MEMORANDUM

To: East Lyme Inland Wetlands Commission
From: Gary A. Goeschel II, Director of Planning/ Inland Wetlands Agent
Date: January 13, 2025

Re: Cedarbrook Lane & Catbird Lane Resubdivision, Heritage Phase 3; Kristen Clarke, P.E., Applicant; Hathaway Farm LLC, Owner; Application for a Resubdivision of approximately 4.1 acres, and Waiver Request from Section 4-2-3(I) Stormwater Management Plan, of land located at Cedarbrook Lane & Catbird Lane, Tax Assessor's Map #36, Lot #31, East Lyme, CT, Zoned RU-40

FIGURE 1

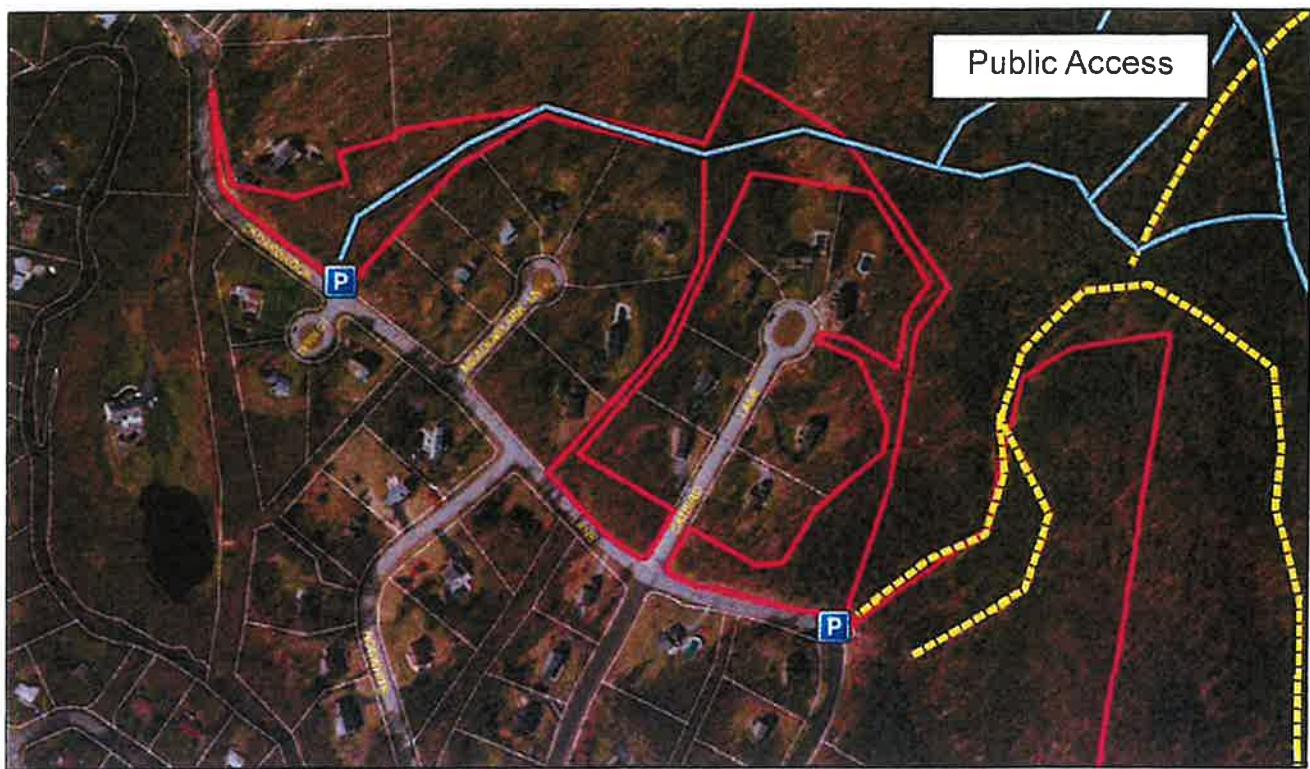
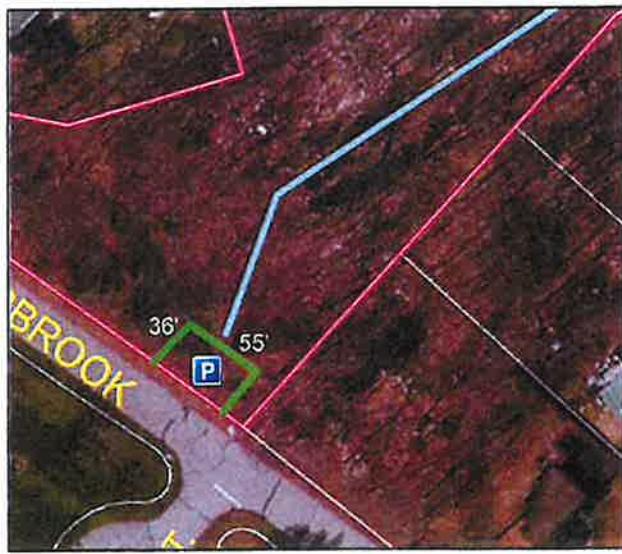
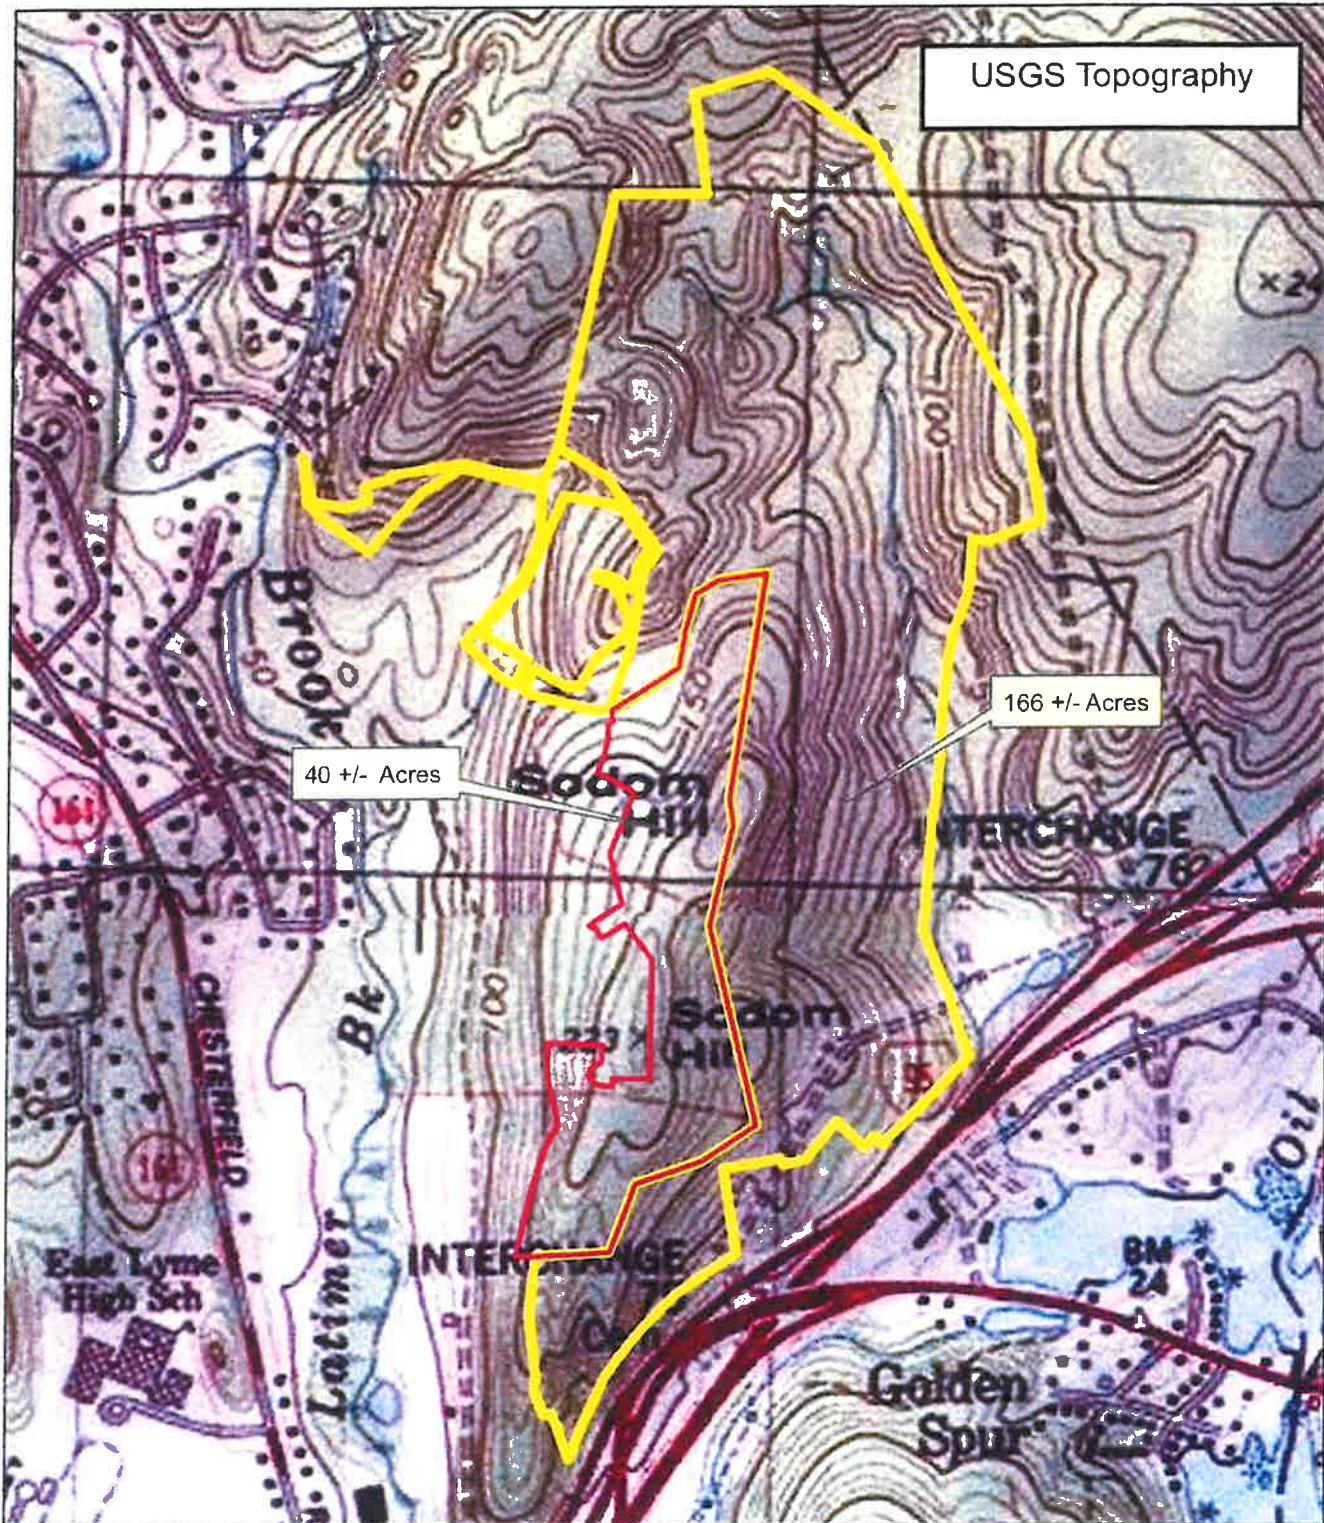
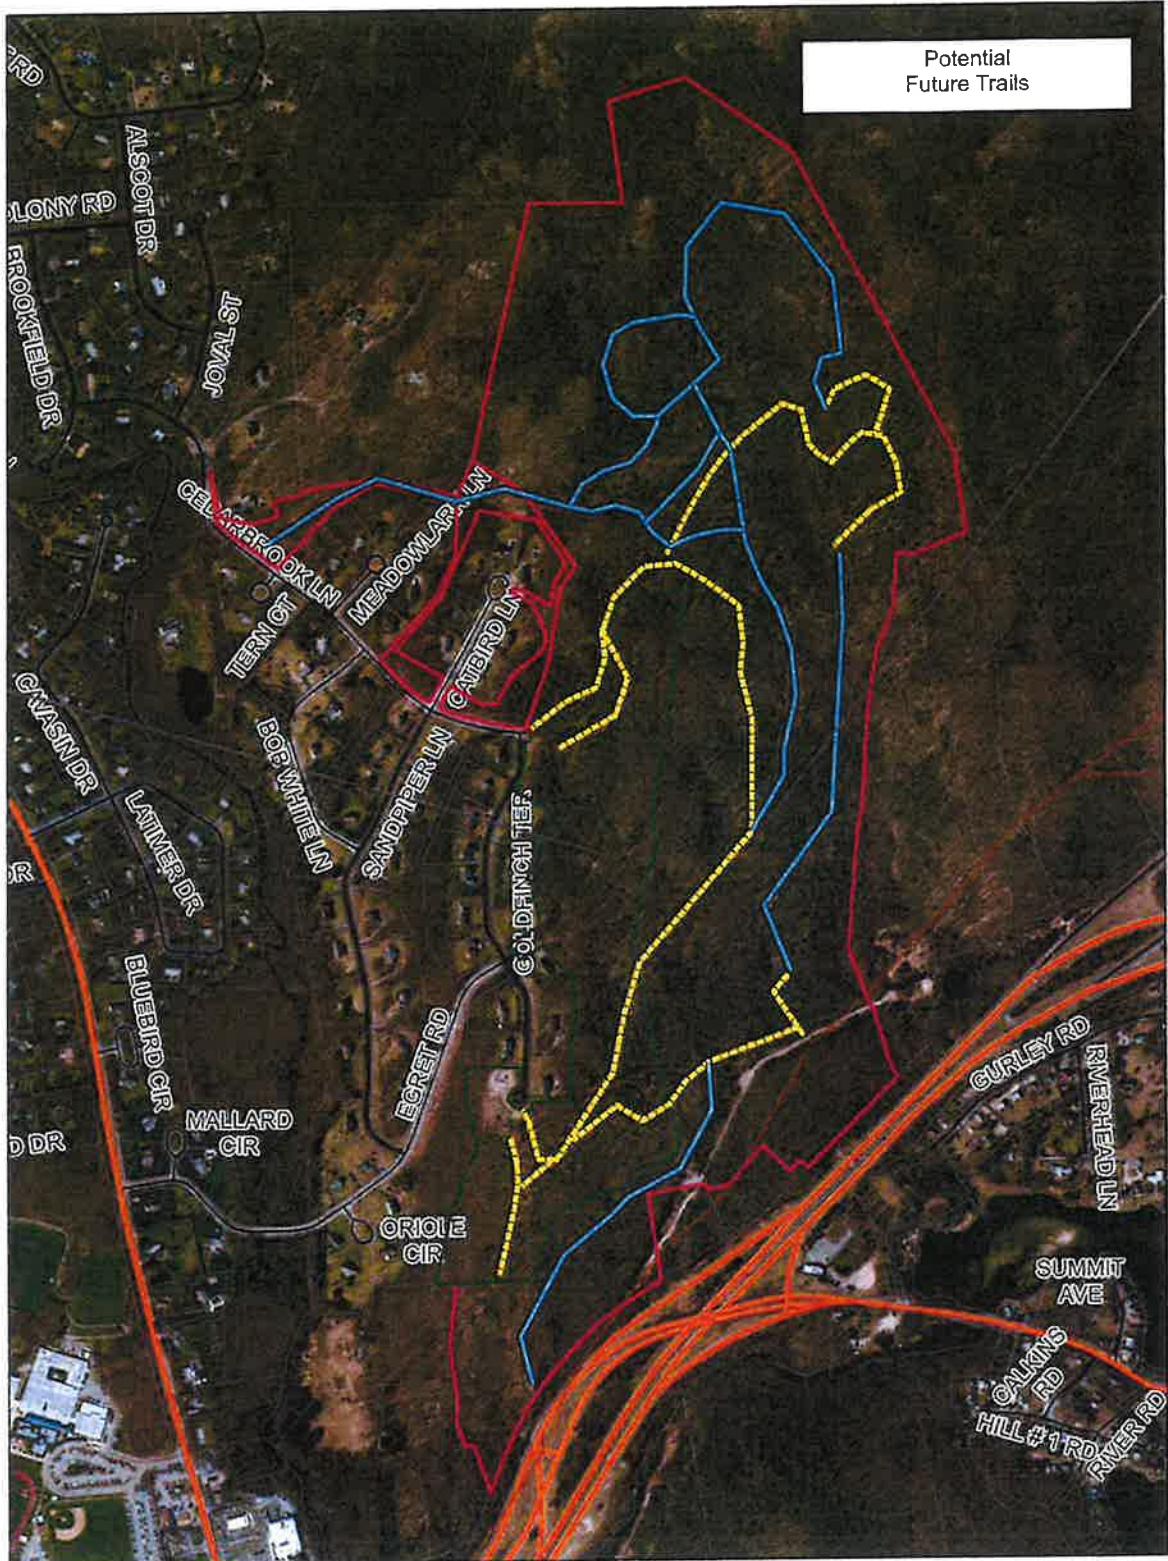
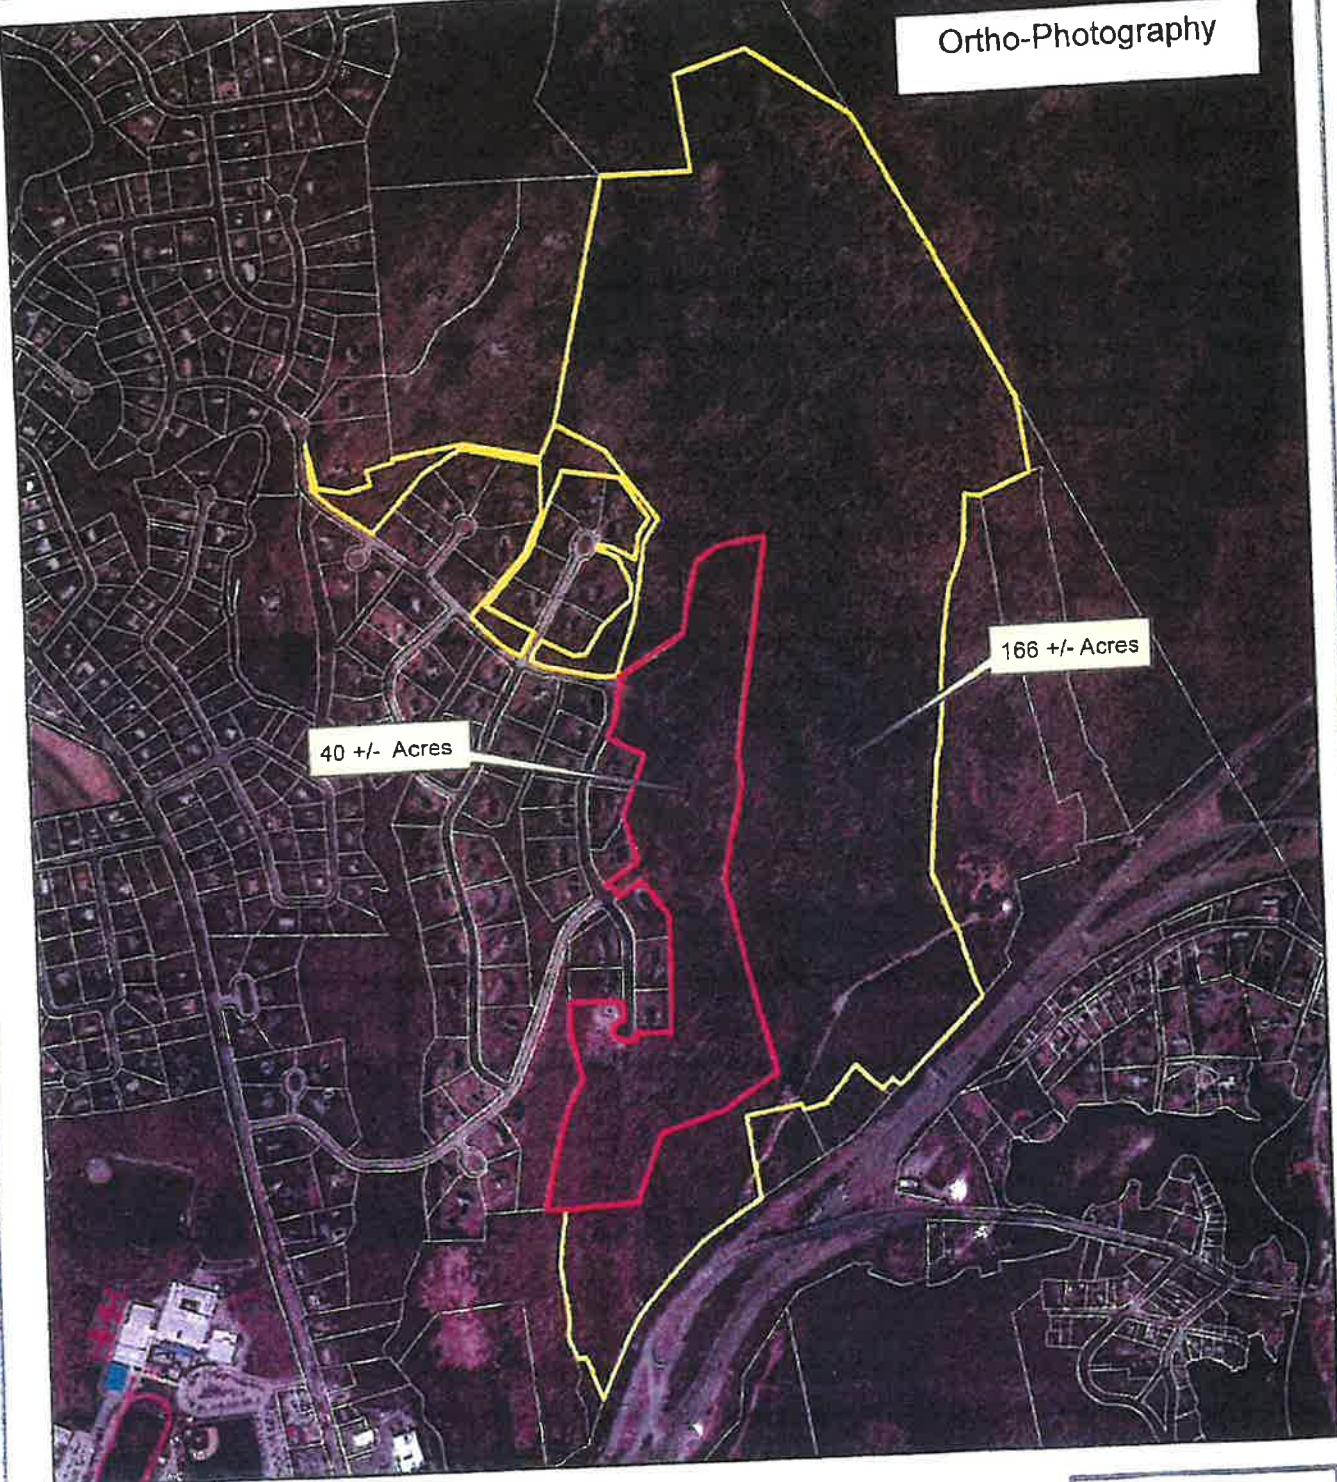
3. On or about July 2012, the East Lyme Planning Department developed several maps for KSK Associates, LLC in support of their application to the Connecticut Department of Energy and Environmental Protection (DEEP) for an Open Space and Watershed Land Acquisition Grant. It was my understanding the grant application proposed two parking areas, one 36' x 55' parking area located in the southeast corner of the subject property for public access to the 200 +/- acres of open space currently owned by the New England Forestry Foundation a (Exhibit 1 attached). As the Grant was awarded and the property

transferred, is there still any obligation for New England Forestry to install this parking area as well as the other proposed 26' x 50' parking area?
